## Borts house - 1945 Santa Fe Avenue

Re: Justifications for proposed FYSB of Borts House

**From:** brian@brianchurcharchitecture.com <brian@brianchurcharchitecture.com>  
**Sent:** Tuesday, July 25, 2023 4:33 PM  
**To:** Jennifer Gavin <jgavin@delmar.ca.us>  
**Cc:** Matt Bator <MBator@delmar.ca.us>; 'Allison Borts' <allisonborts@gmail.com>  
**Subject:** RE: Borts - DRB Staff report

**BORTS**  
1945 SANTA FE AVENUE, DEL MAR, CA 92015

AREA PLANS

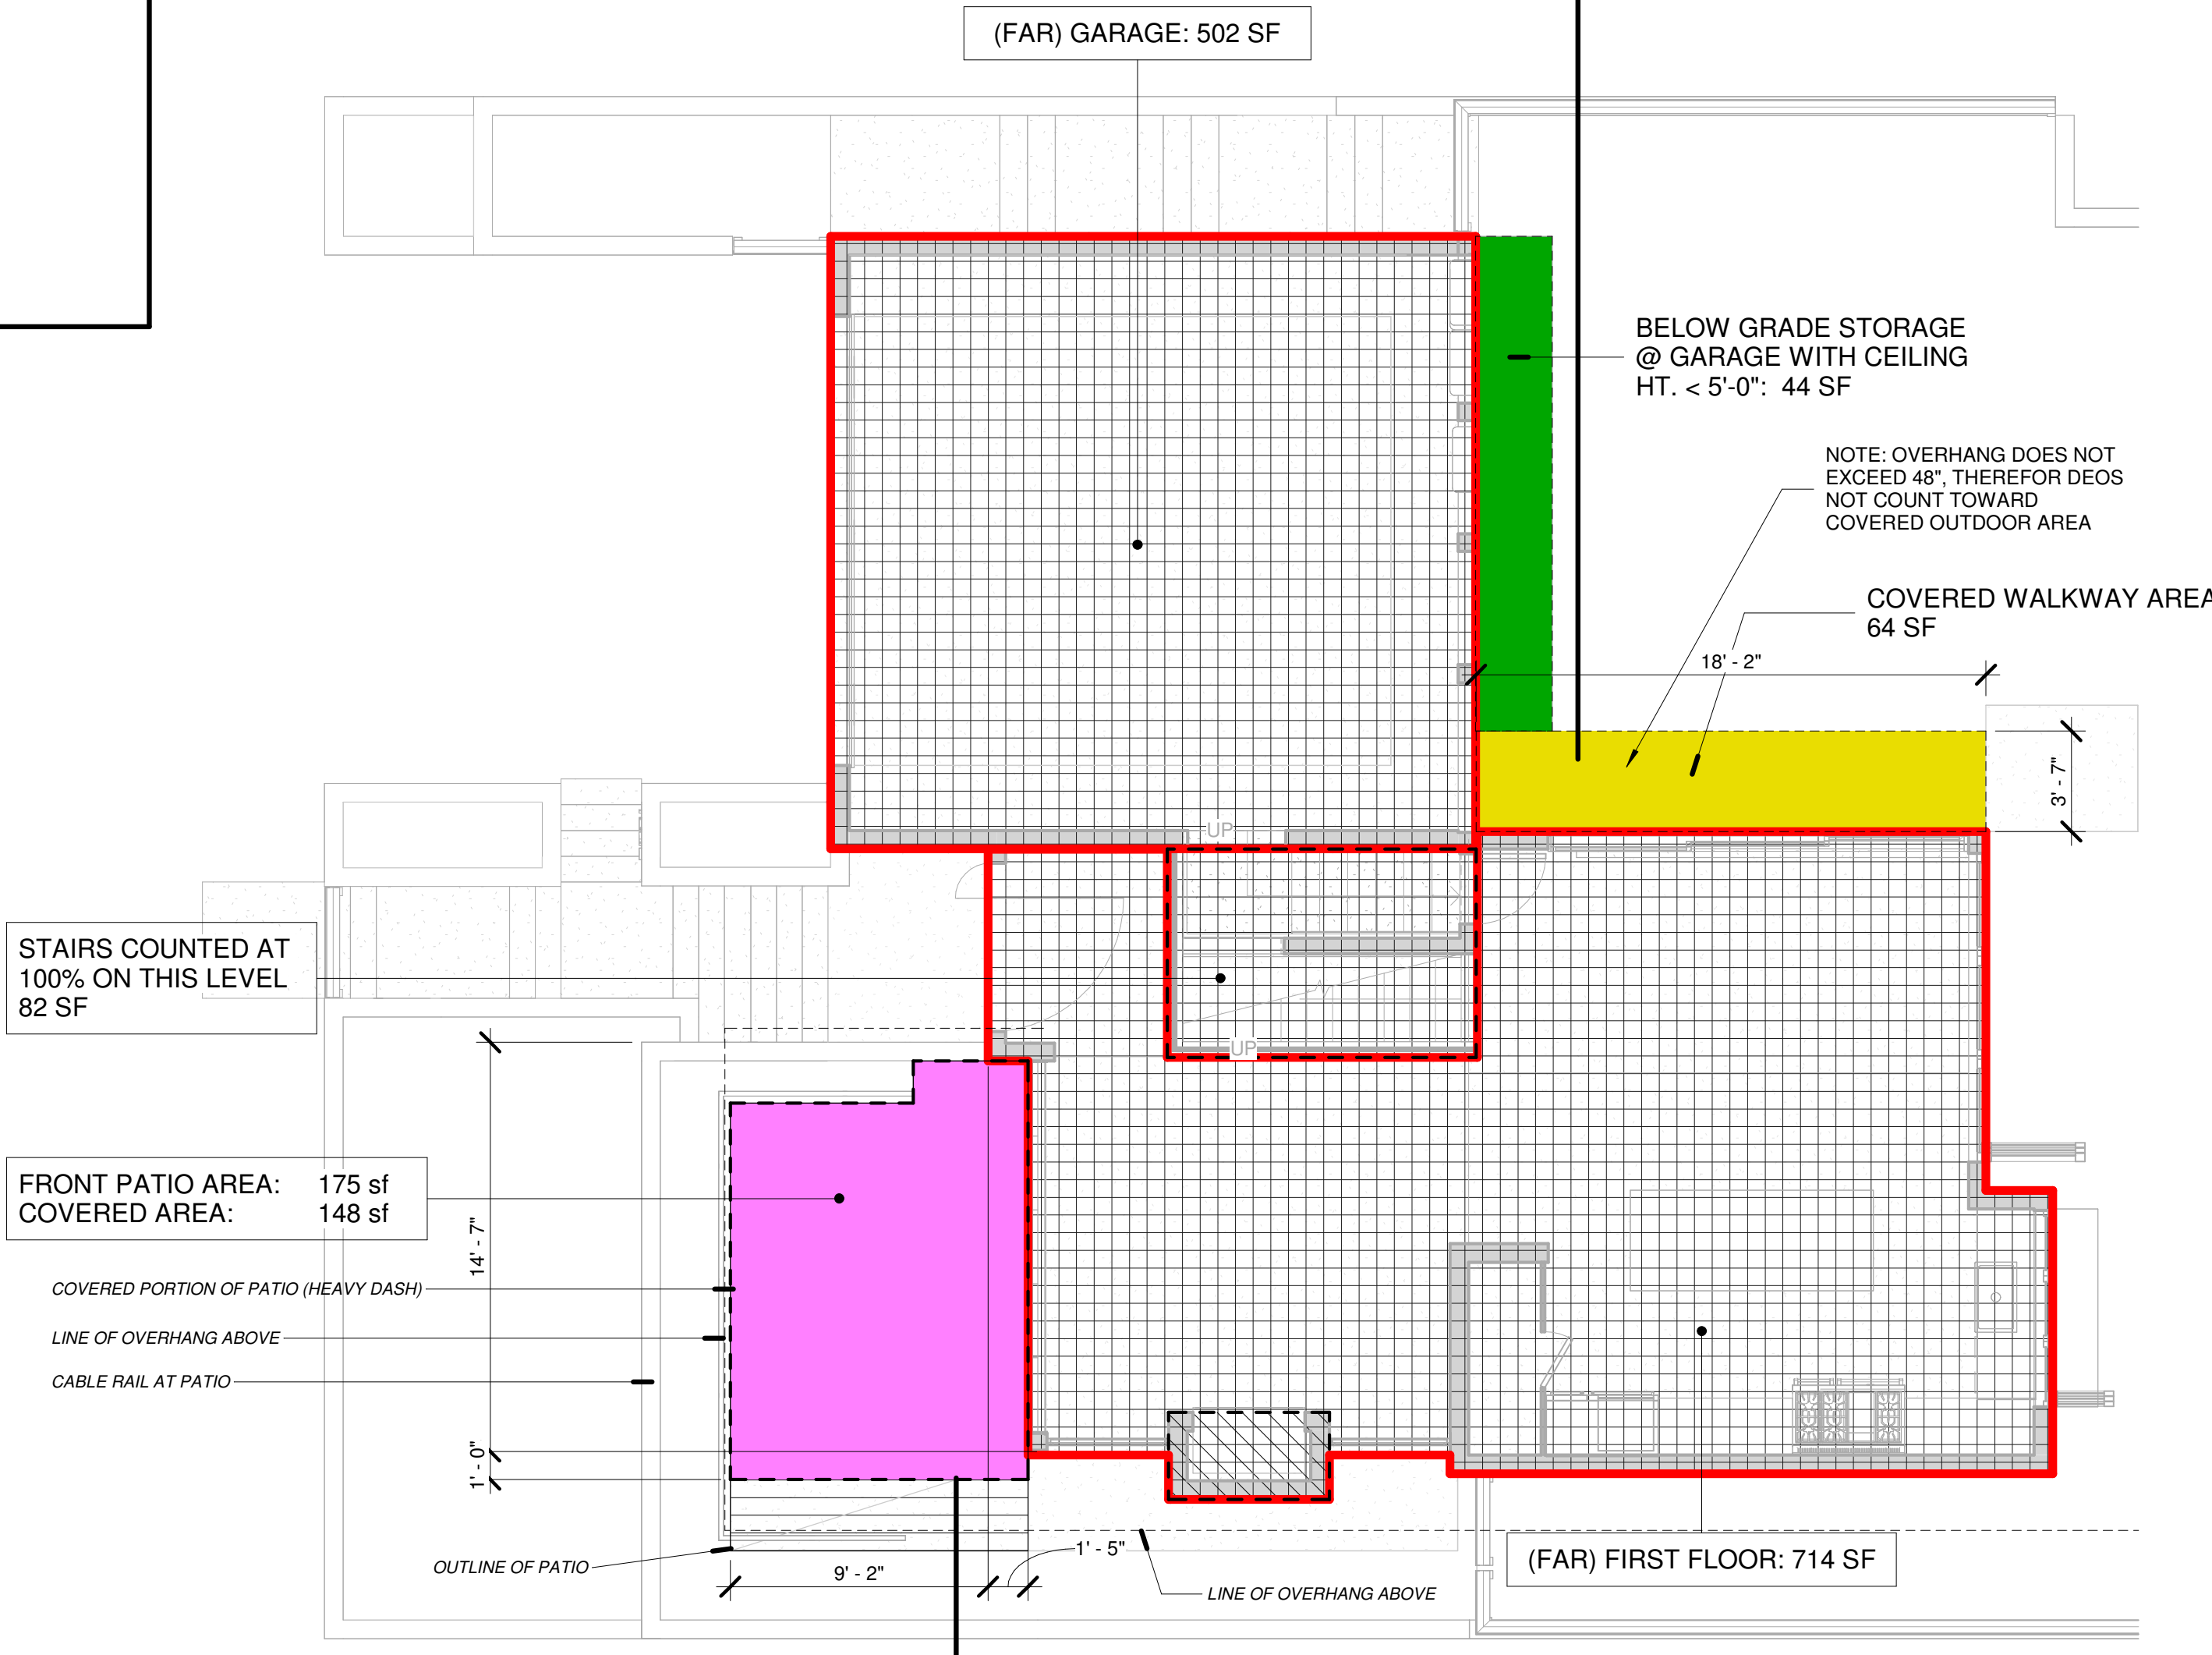
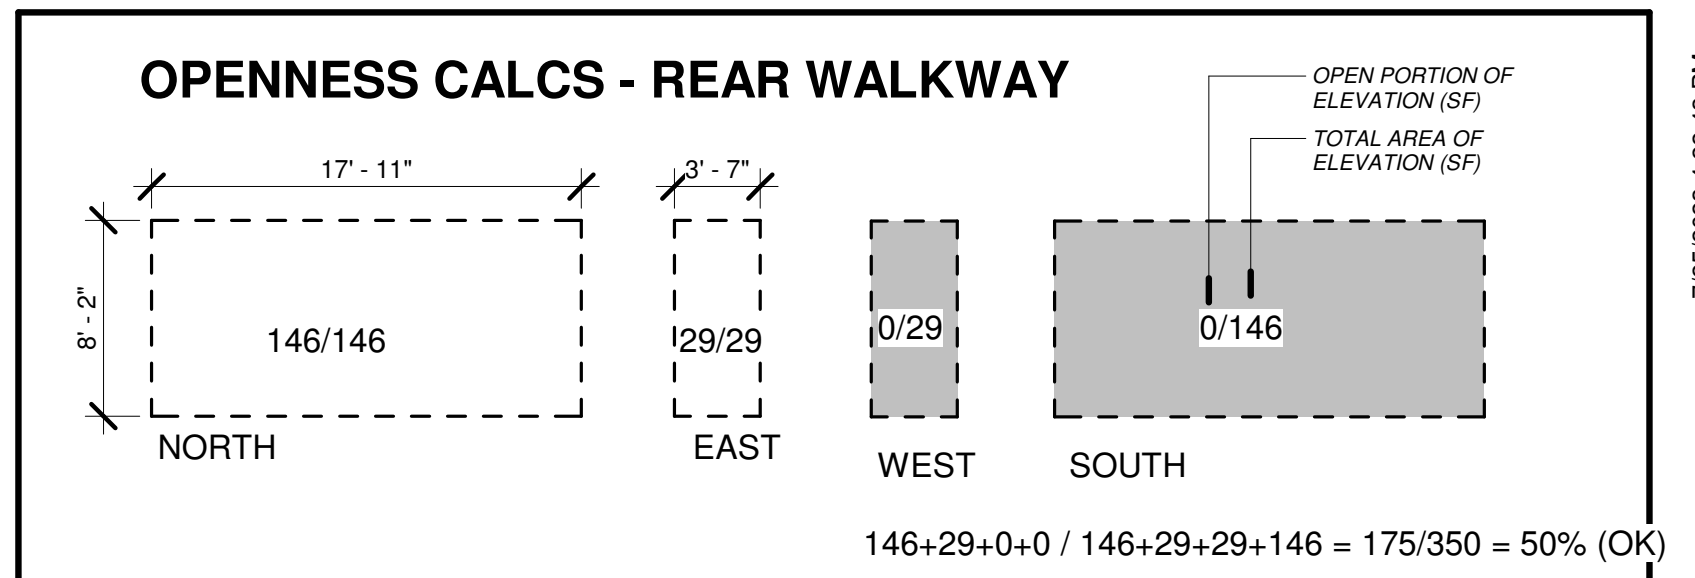
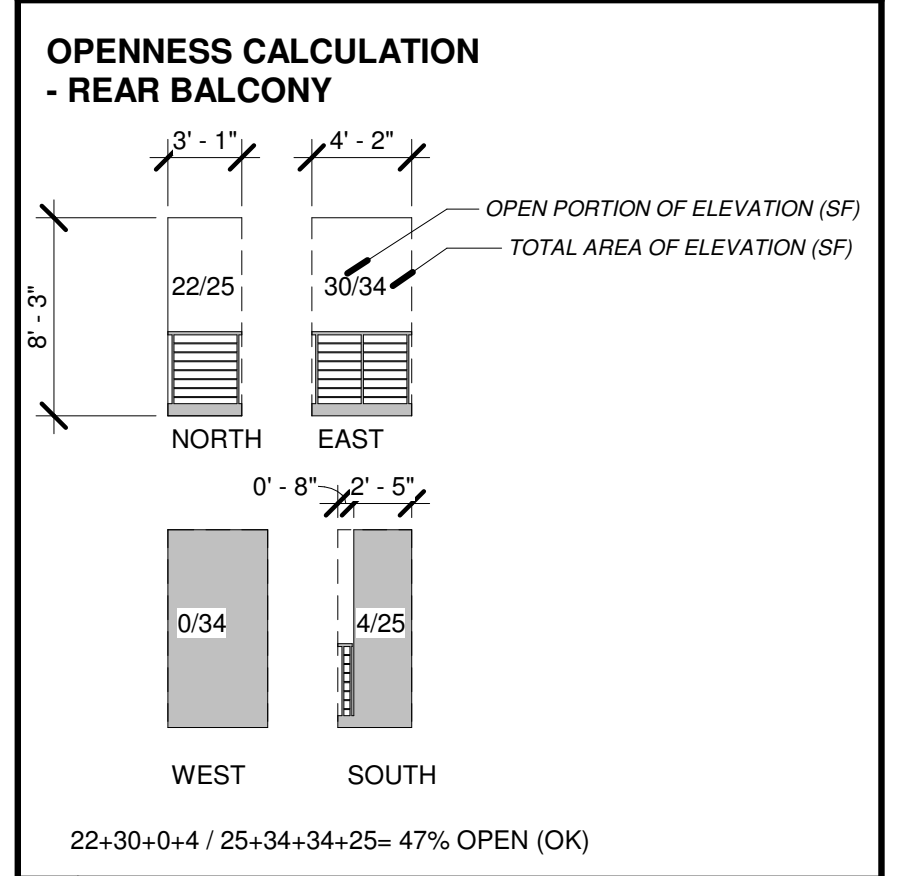
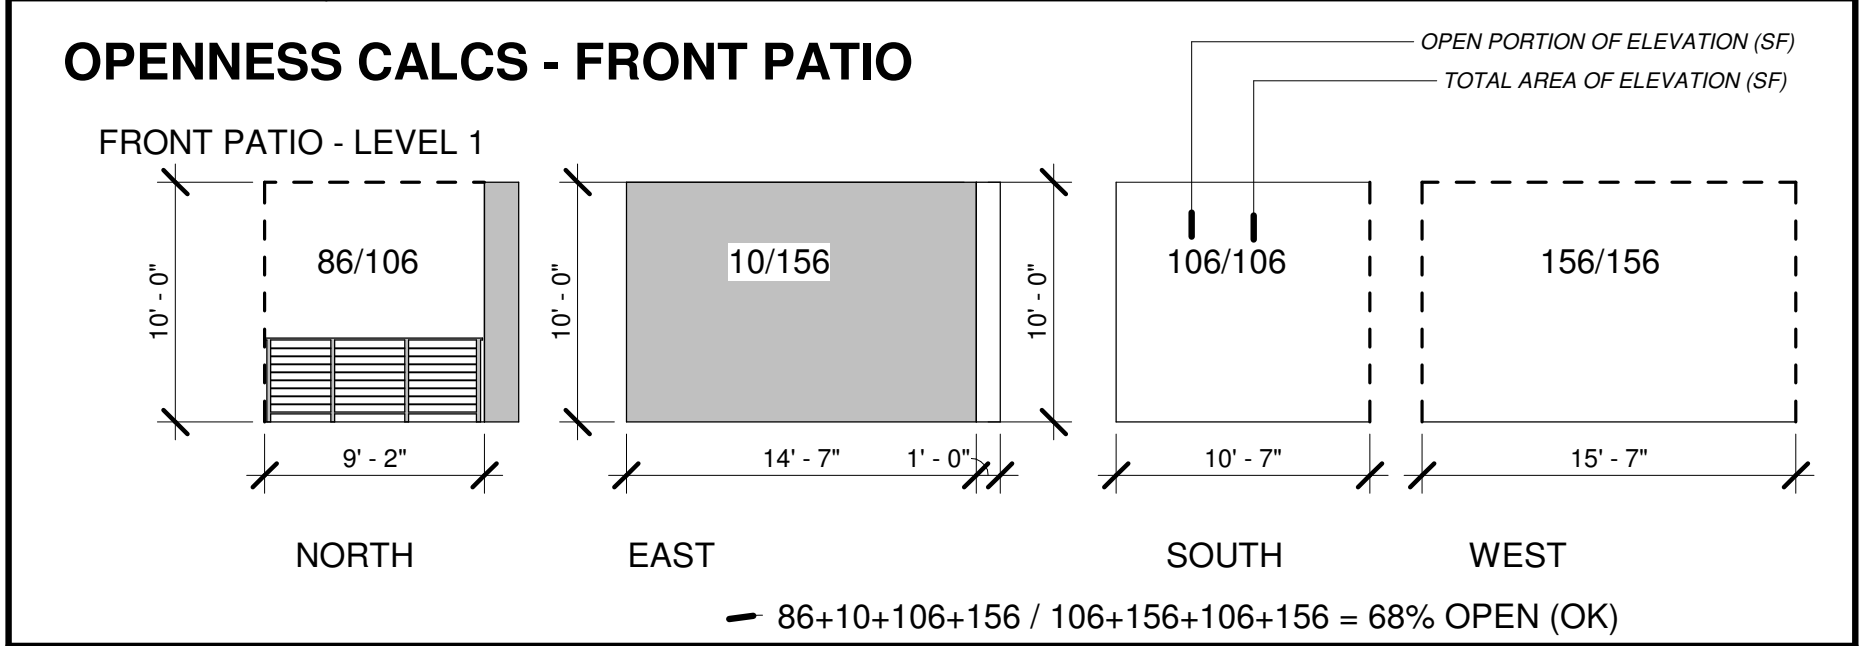
I am attaching a revised sheet A0 (Area Plans). I have highlighted the various area types in color to more clearly illustrate the FAR exempt areas being referenced.

I added colors (pink and green) to the legend to indicated the areas reference in Section D.3 that are recommended to be limited to 15% of the allowable FAR. Please note that the green area is below grade.

It is my understanding that overhangs of less than 48" (yellow) are just overhangs and should not contribute to the areas referenced in D.3. Please note that there are NO OVERHANGS elsewhere on the house, which would be typical for a traditional house.
